**AGENDA
MANOR PLANNING AND ZONING COMMISSION
105 E. EGGLESTON ST.
MANOR, TEXAS 78653
DECEMBER 9, 2015, 6:30 P.M.**

Re: First Construction Plan and Final Plat Review for
Shadowglen Phase 2, Section 20 Subdivision
City of Manor, Texas

Re: First Final Plat Review for
Presidential Heights – Phase 1
City of Manor, Texas

Re: First Concept Plan Review for
Lagos Master Planned Community
City of Manor, Texas

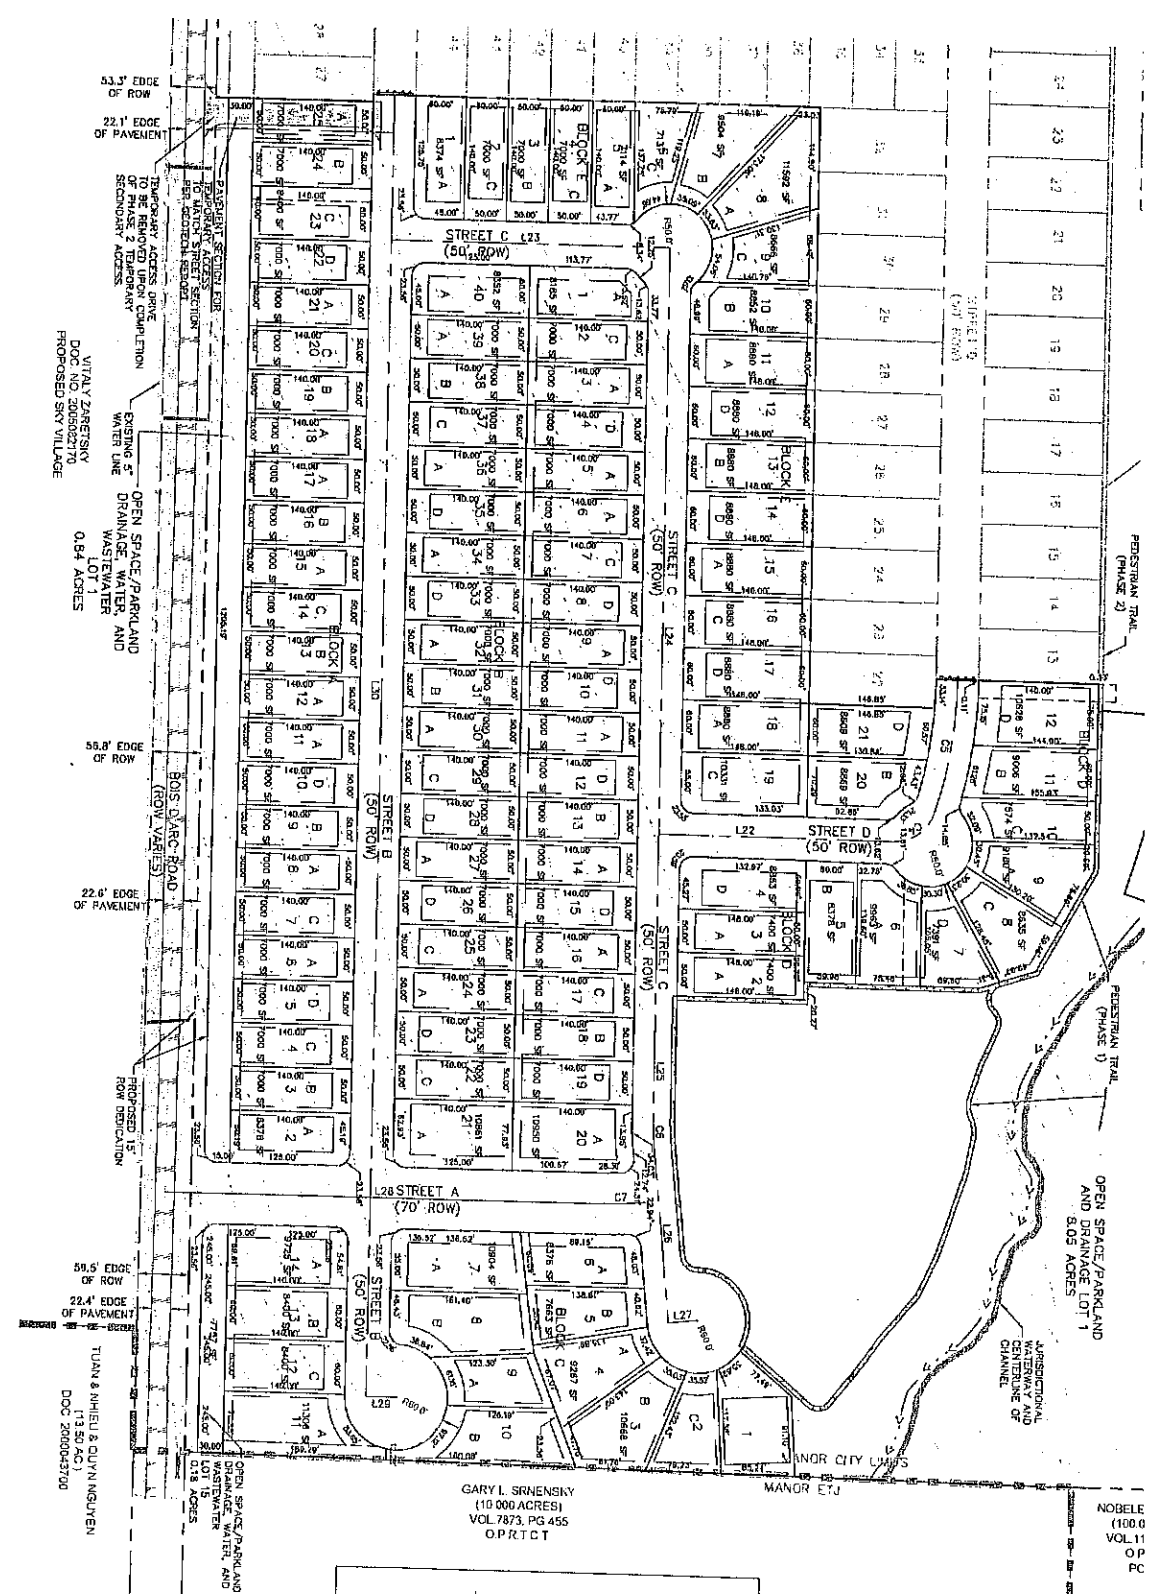
6. Section 24(c)(4)(ii) requires that complete curve data (delta, arc length, radius, tangent, point of curve, point of reverse curve, point of tangent, long chord with bearing) be provided.

Response: Curve table added to Sheet 3.
